Our Ref: 20227

**RE: MEDI-HOTEL DEVELOPMENT 28-32 SOMERSET STREET KINGSWOOD
DA22/0326 RESPONSE TO ISSUES – TRAFFIC**

Attachment – Car Park Review (File 20227CAD022-220328-CAR PARK REVIEW-13.pdf)

TITLE: **SWEPT PATH ANALYSIS - BASEMENT LEVEL 1
 AS2890.1 5.2m B99 VEHICLE**

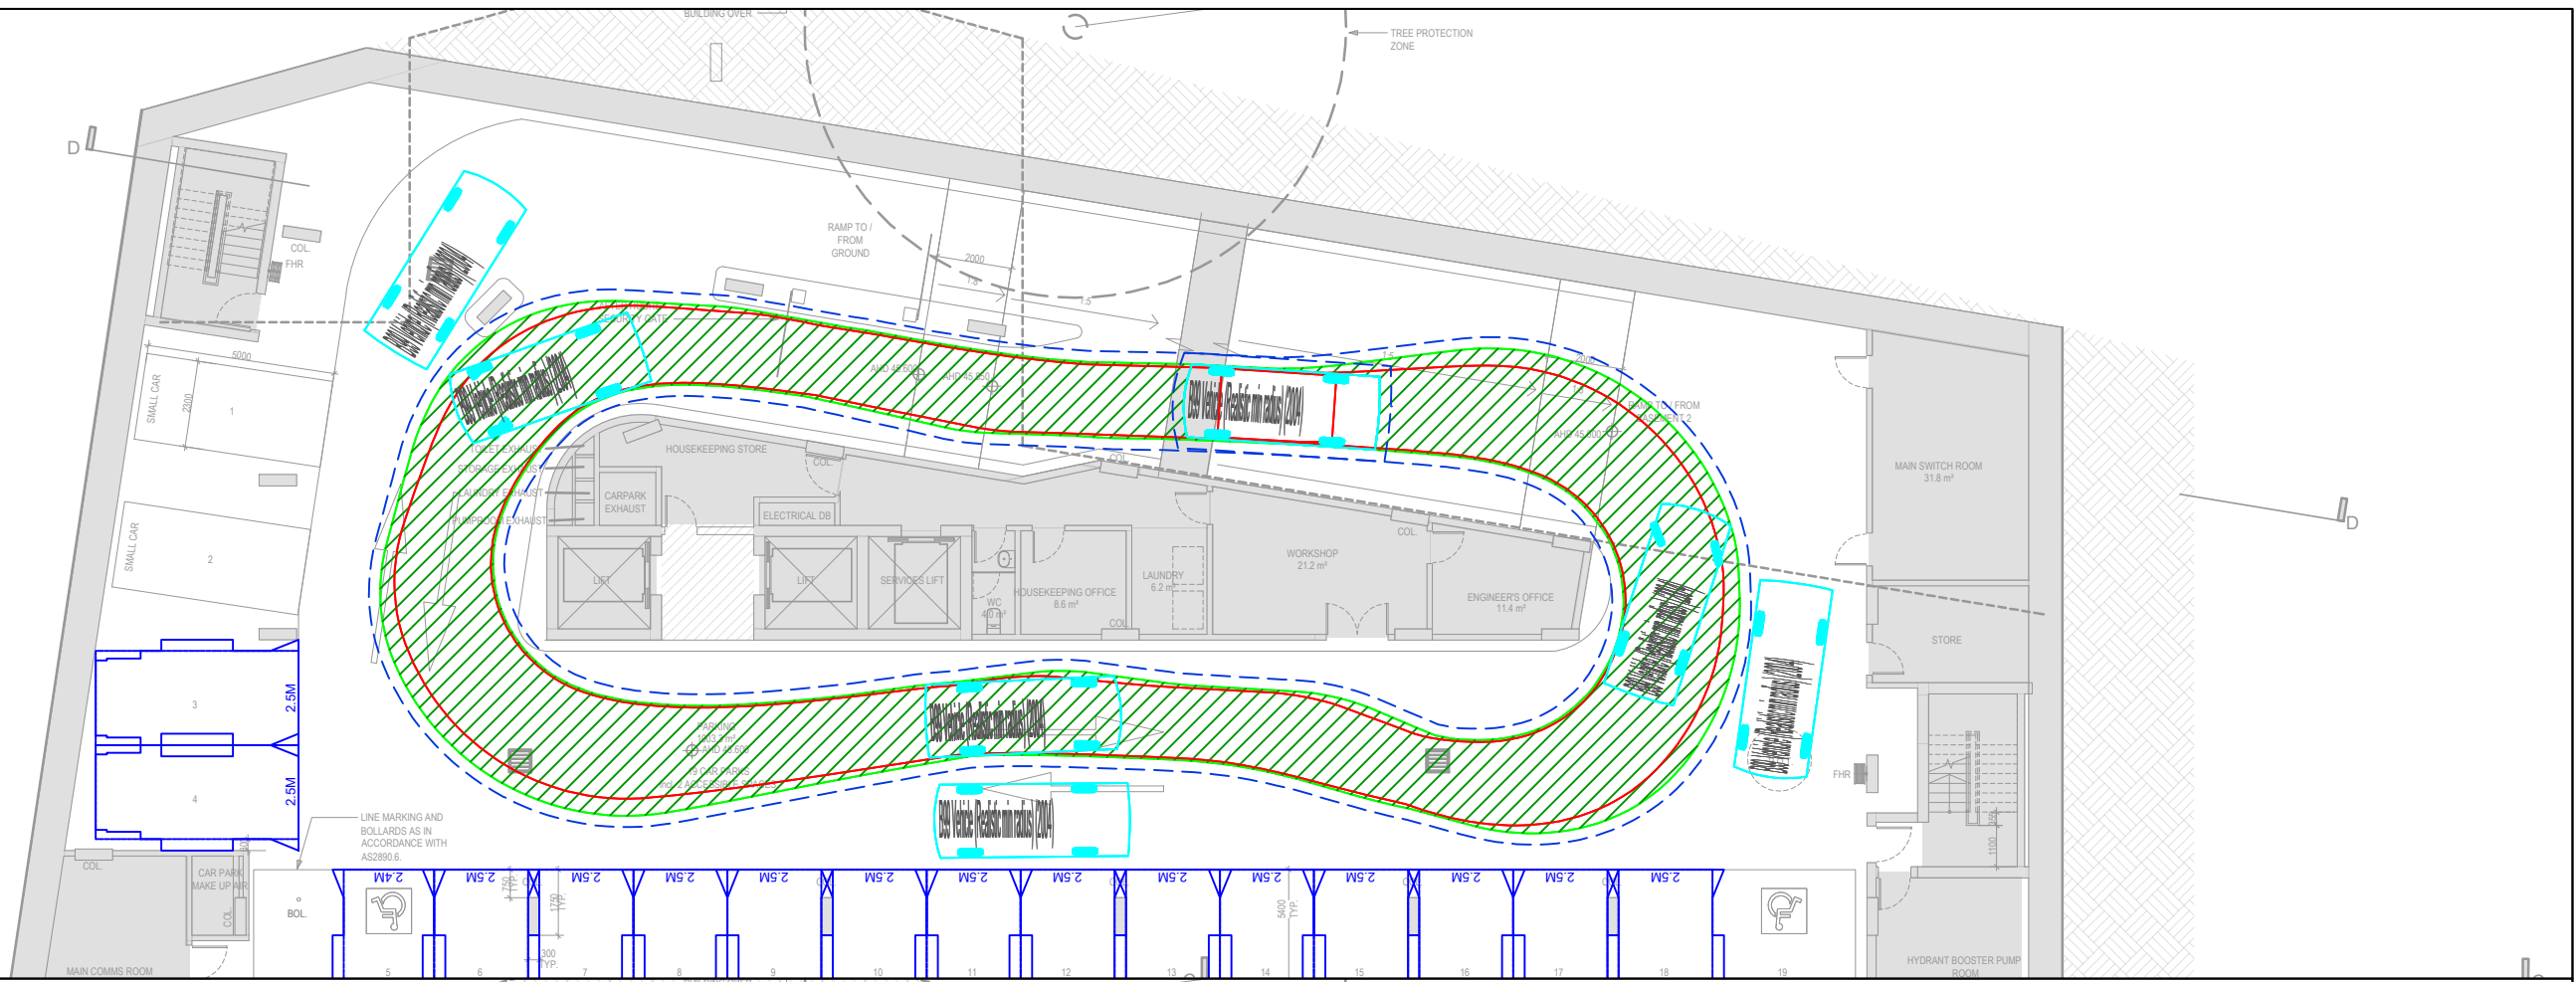
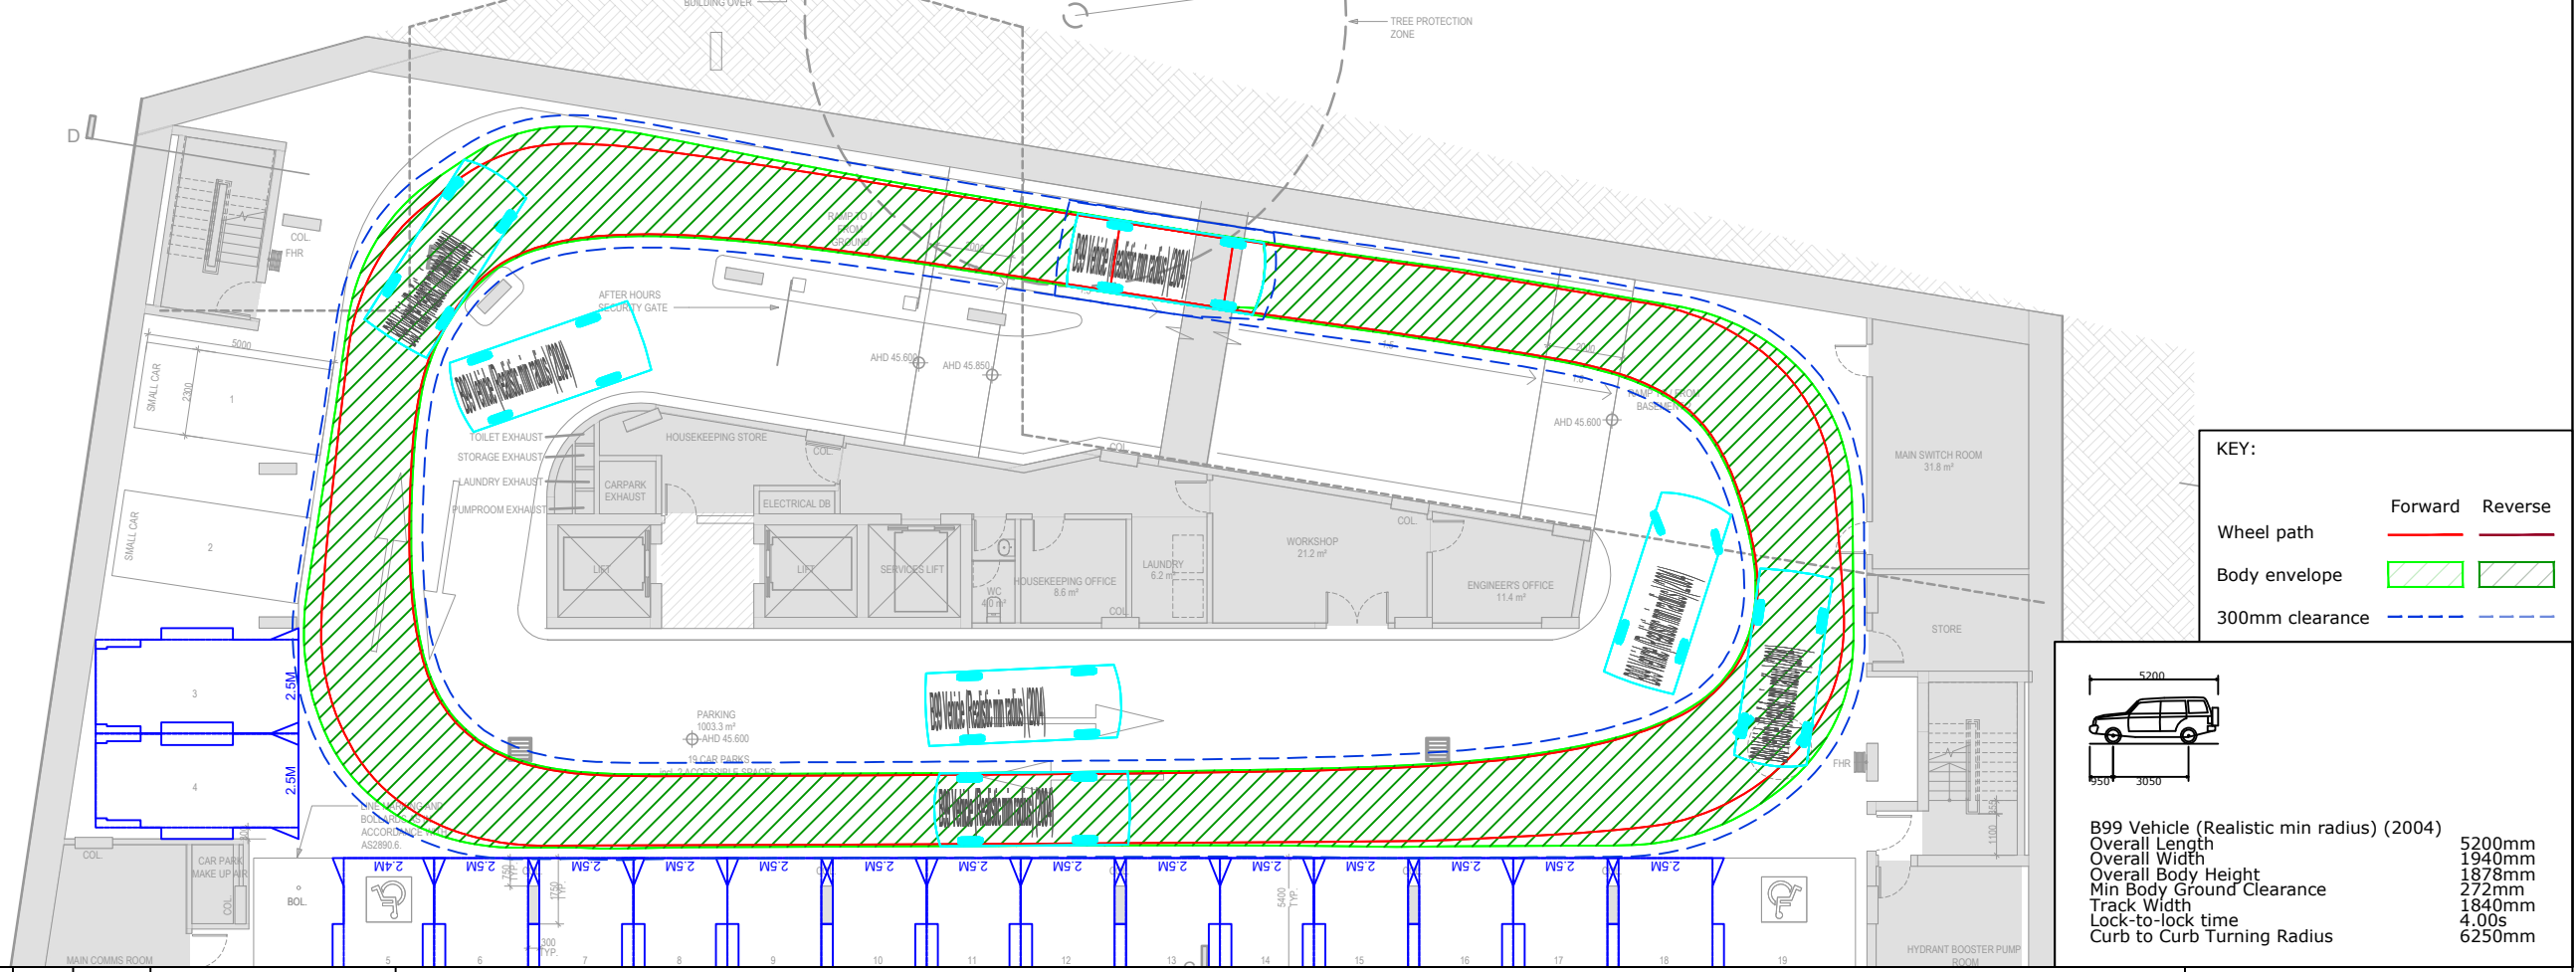
The architectural drawings of the basement carpark show a structural column located in the middle of the access roadway across from the staircase. This column may cause difficulty for vehicles entering and exiting the basement carpark. A swept path is required to demonstrate that vehicles are able to manoeuvre around this column while entering and exiting the basement and from the parking spaces no. 1, 20 and 40.

Refer to earlier response, the requested swept paths around the column are included in the attached review of the car park.
